WBN-TS-03-09

**WATTS BAR NUCLEAR PLANT (WBN) – LICENSE AMENDMENT (WBN-TS-03-09) TO REVISE THE TECHNICAL SPECIFICATIONS AND BASES FOR THE DELETION OF THE UNIT 2 VITAL INVERTERS**

PROPOSED LICENSE AMENDMENT REQUEST WBN-TS-03-09  
DESCRIPTION AND EVALUATION OF THE PROPOSED CHANGE

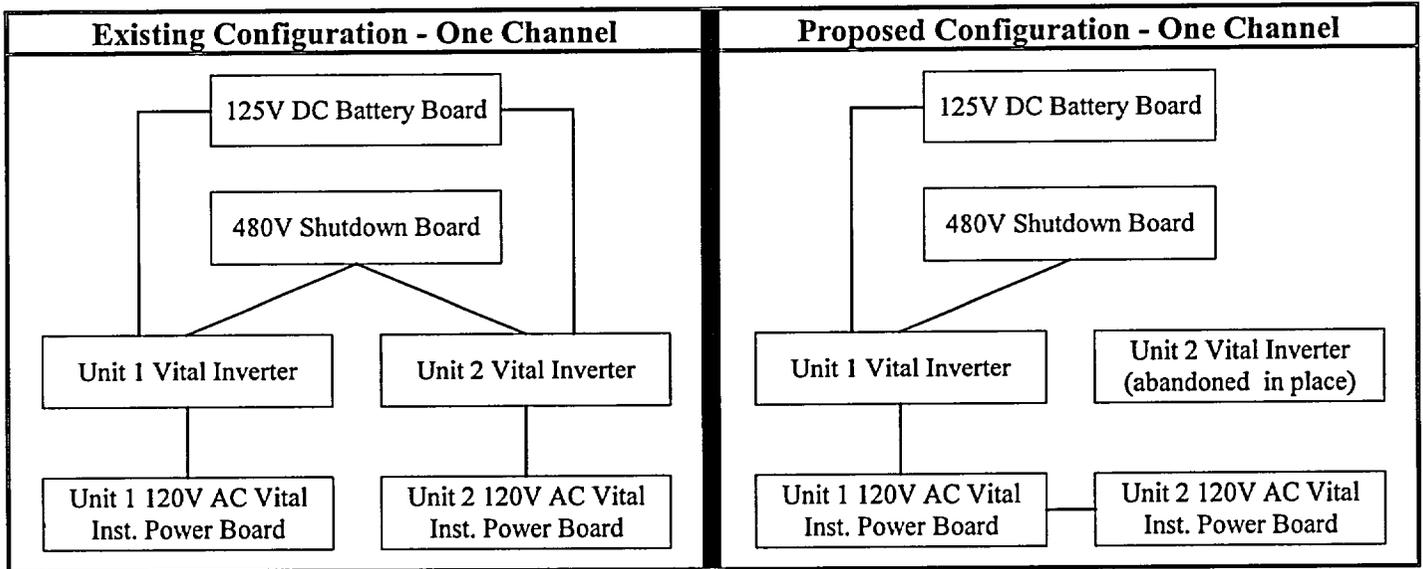
The Unit 2 120V AC Vital Instrument Power Boards presently receive their uninterruptible power supply (UPS) from the Unit 2 120V AC Vital Inverters. The proposed amendment modifies the configuration of the four channels so that each Unit 2 Vital Instrument Power Board receives power from the 120V AC Vital Inverter supplying the associated Unit 1 120V AC Vital Instrument Power Board through the Unit 1 120V AC Vital Instrument Power Board. A simplified diagram of the proposed change is provided below:

**WBN Unit 1 - Vital AC**  
**Proposed Configuration to be implemented During Cycle 5**

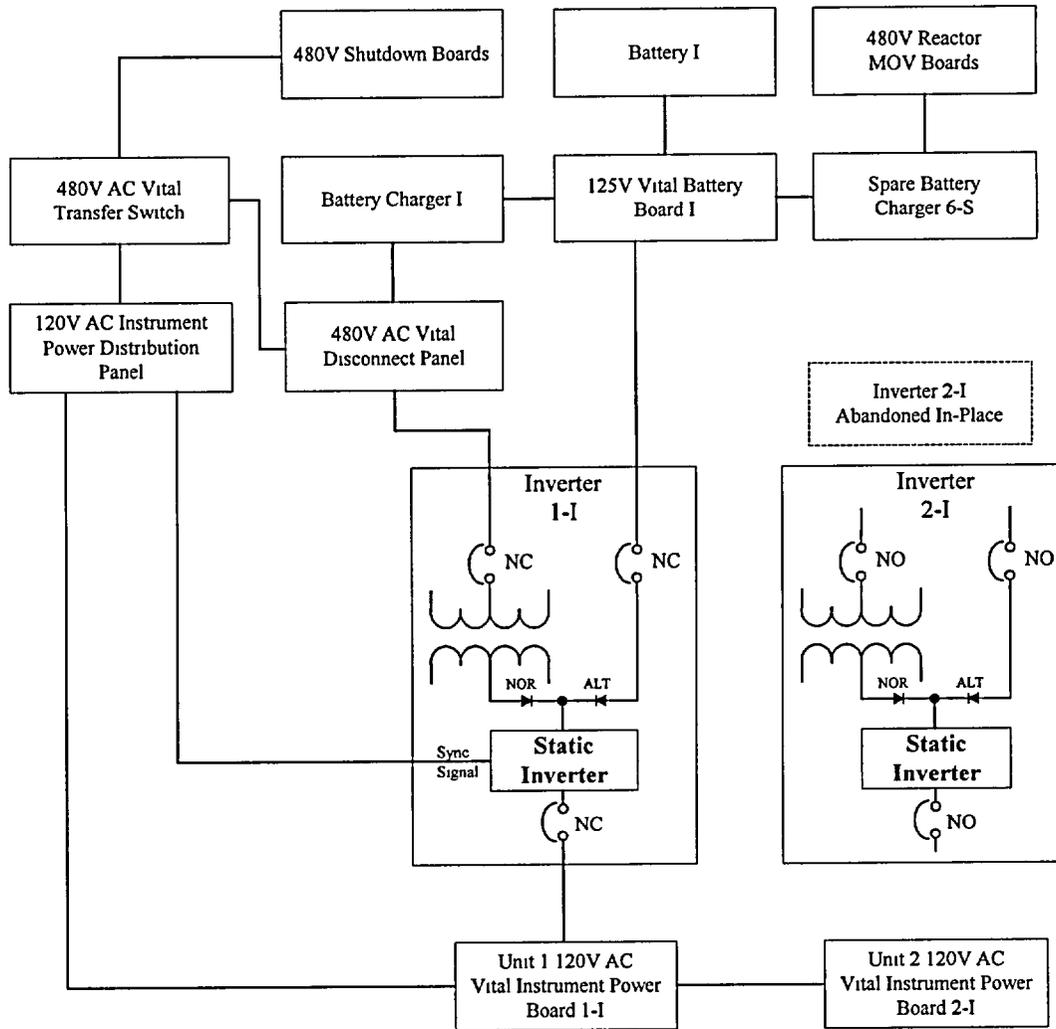
- A. The 480V AC Vital Disconnect Panels will be physically installed in the plant along with the required conduit and cabling. The disconnect panels provide the capability to individually isolate the 480V loads from the transfer switch. This feature improves personnel safety and will facilitate the future replacement of the vital inverters.

- A. The cables for the disconnect panels will be terminated.
- B. The Unit 1 and Unit 2 Vital Instrument Power Boards will be connected together so that the both units are supplied from the Unit 1 inverter.
- C. The Unit 2 inverters will be abandoned in-place.

**WBN Unit 1 - Vital AC  
Configuration to be implemented During Cycle 6 (Conceptual Design)**

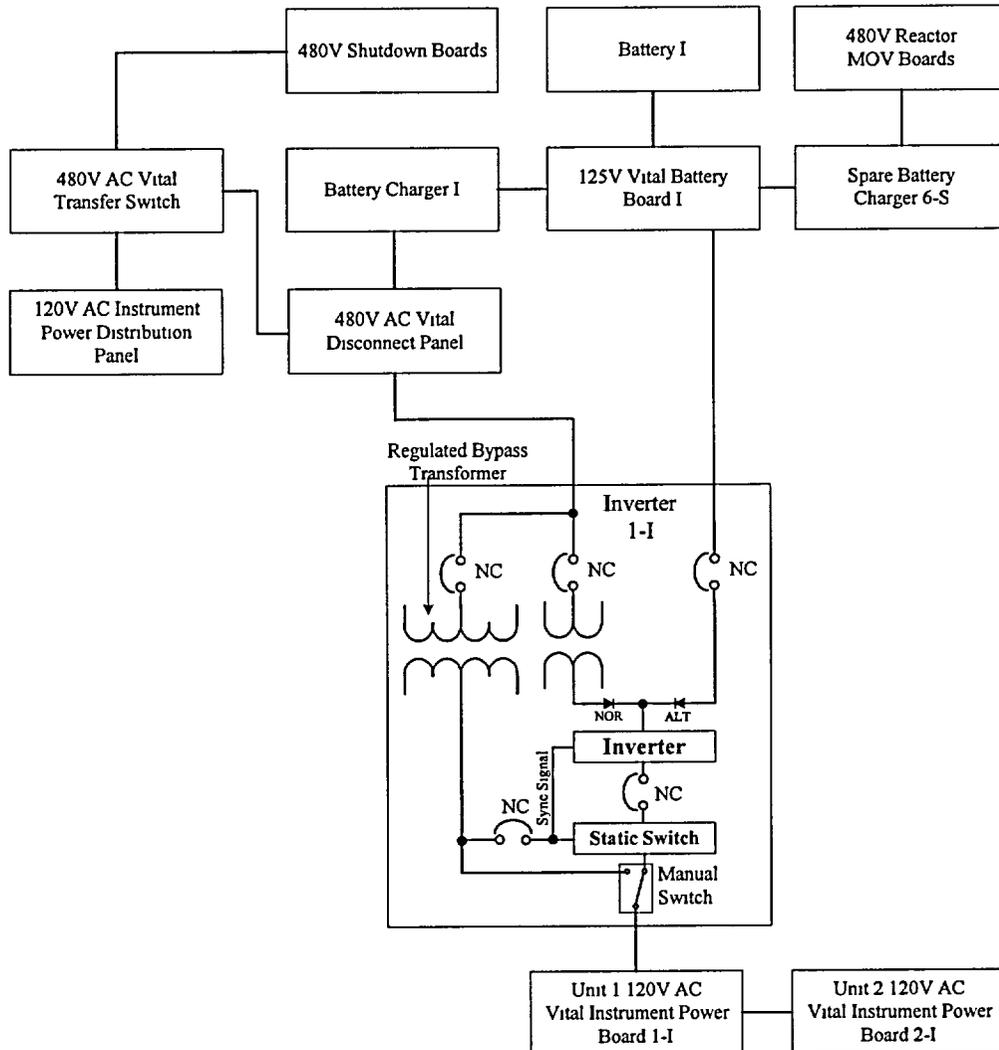
- A. The abandoned Unit 2 inverters will be removed and the new inverters will be installed. The new inverters will have regulated bypass transformers and static switches. The uninterruptible power supply (UPS) output will automatically transfer to the regulated bypass transformer in the event of inverter failure or overload.
- B. Initiate, if required, a license amendment request to address unit operation with the new inverters.

- A. The electrical connections for the old Unit 1 inverters will be removed and the equipment will be abandoned in-place.
- B. The electrical connections for the new inverters will be terminated.
- C. The new inverters will be appropriately tested prior to being placed into service as the Unit 1 inverters.

**WBN Unit 1 - Vital AC  
Configuration to be implemented During Cycle 7 (Conceptual Design)**

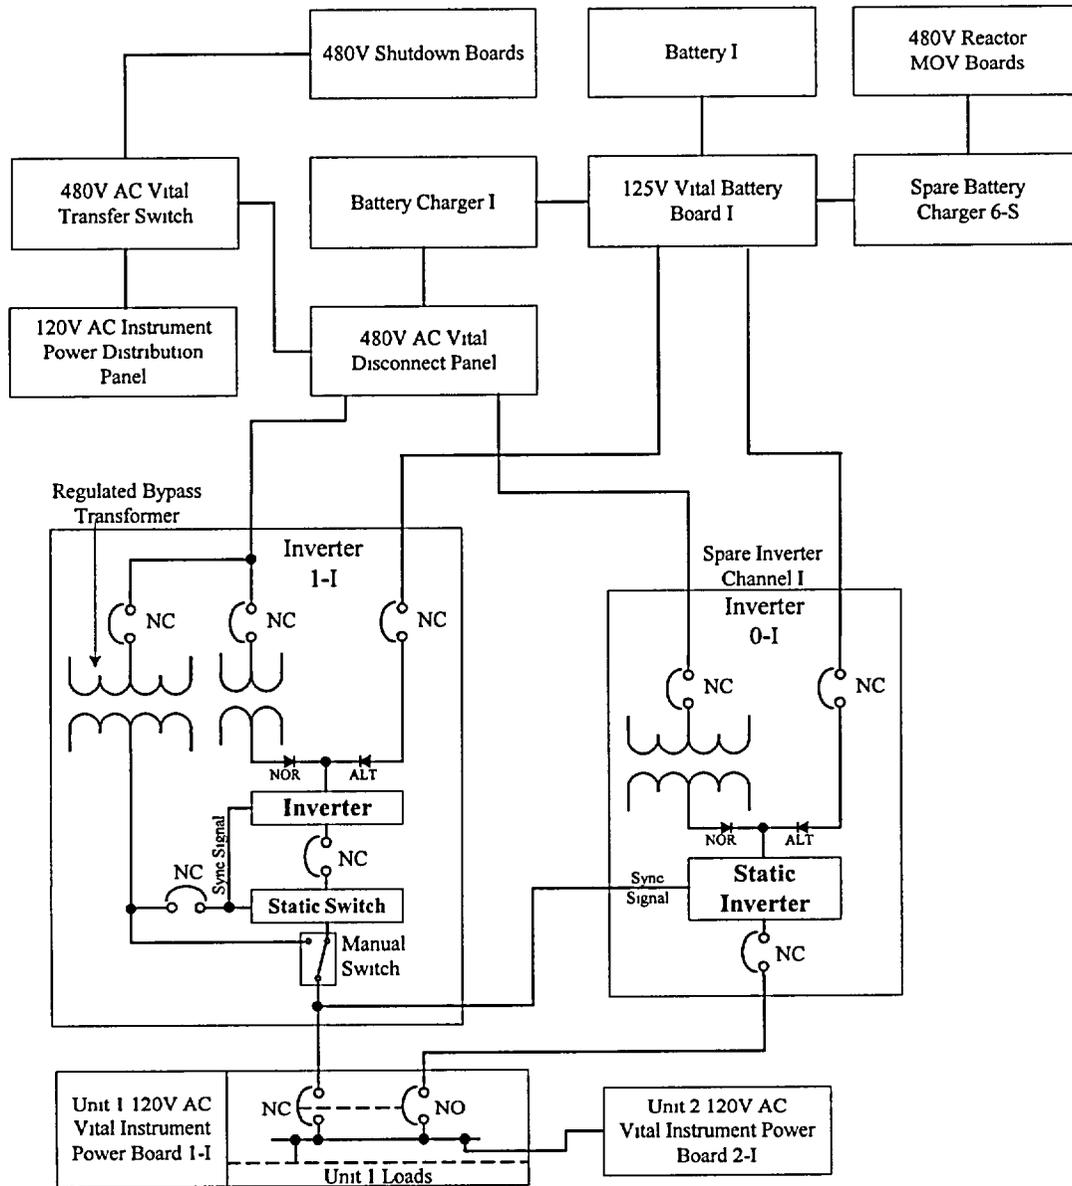
- A. The abandoned old Unit 1 inverters will be removed and new spare inverters will be installed. The new spare inverters will not have static switches or regulating bypass transformers.
- B. Initiate, if required, a license amendment request to address operation of the spare inverters.

- A. The electrical connections for the new spare inverters will be terminated.
- B. The new spare inverters will be appropriately tested prior to being placed into service.
